**U.S. NUCLEAR REGULATORY COMMISSION**

**FINAL SAFETY EVALUATION FOR**

**TOPICAL REPORT WCAP-16996-P/WCAP-16996-NP, VOLUMES I, II, AND III, REVISION 1,**

**“REALISTIC LOSS-OF-COOLANT ACCIDENT EVALUATION METHODOLOGY**

Figure 1: A Characteristic PCT Response to Break Size Variation Observed in Analyses Using 10 CFR Part 50 Appendix K and in Power Uprate Small Break LOCA Analysis

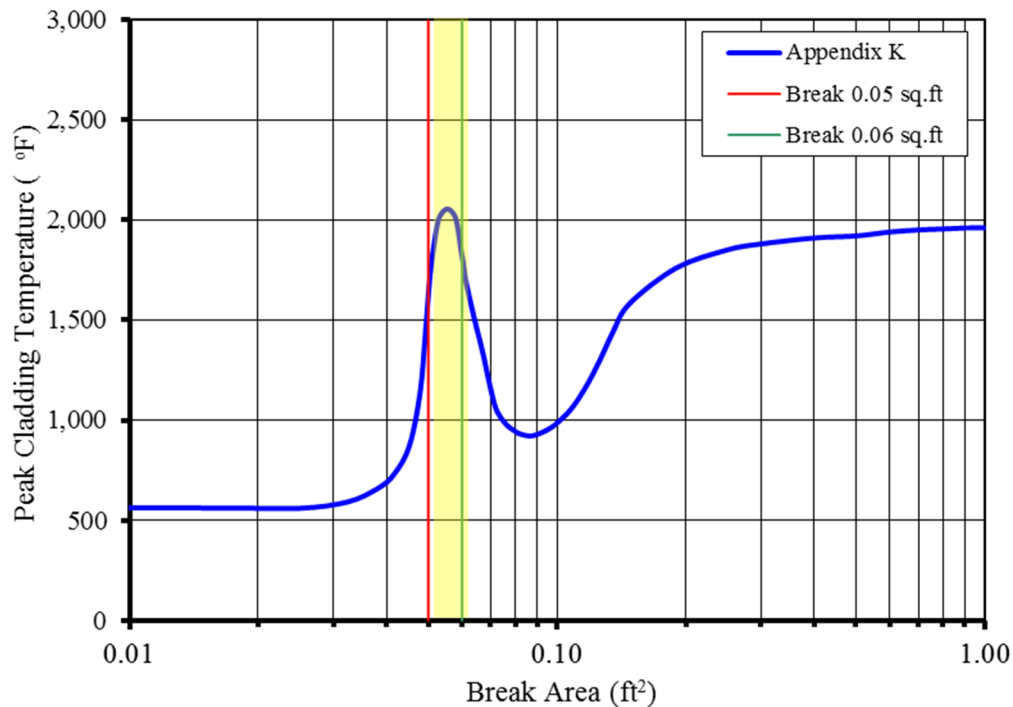
A typical small break spectrum analysis produces a characteristic PCT versus break size response, which is shown in Figure 1. Of particular significance in this response is the observed limiting break region with a maximum in the PCT at approximately 0.055 ft<sup>2</sup>. The depicted PCT vs break size curve is typical of plants with low capacity high pressure safety injection pumps or those undergoing extended power uprates. It is important to further note that for some plants the predicted PCT can increase by a few hundred degrees Fahrenheit when the break size changes within the limiting break region from approximately 0.05 ft<sup>2</sup> to 0.06 ft<sup>2</sup>. For example, it has been observed for many PWR plants that the PCT can increase by ~100 °F when the break area changes by as little as 0.005 ft<sup>2</sup> within this break region so that the PCT at a 0.055 ft<sup>2</sup> break is considerably higher than the PCTs at both 0.05 ft<sup>2</sup> and 0.06 ft<sup>2</sup> breaks. Furthermore, this limiting break region is characterized by a RCS pressure that depressurizes to a pressure value just above the safety injection tank (SIT) or accumulator actuation pressure. Because such behavior characterizes a large number of PWR plants, it is necessary to resolve the limiting break region confining the worst break controlled entirely by the high pressure injection pump. The core uncover period for breaks in this limiting range of relatively small breaks can be as long as 45 minutes to one hour. For some plants, the two-phase mixture level in the core can recede slowly to depths near the core mid-plane during this period. Such long term core uncover LOCAs emphasize the significance of the BE two-phase level swell modeling and PCT, controlled by interfacial drag, steam cooling heat transfer, loop seal clearing behavior, decay heat, and condensation at the safety injection port, to name the most significant. Clearly, with the core being uncovered for a period of up to one hour, very small changes in the core two-phase mixture level during such uncover periods can result in very large PCT changes.

Given the above discussed issues and the fact that the WCOBRA/TRAC-TF2 code has no proven history of successful simulation of SBLOCAs, the NRC staff formulated the following approach to identifying and analyzing the limiting break region for the SBLOCA spectrum as illustrated in Figure 1. The entire small break spectrum (Region I) is defined as:

In general, the limiting break region will lie between 2 inches and 4 inches in equivalent break diameters in the cold leg, but may differ slightly due to plant power level, geometry, and ECCS characteristics. [
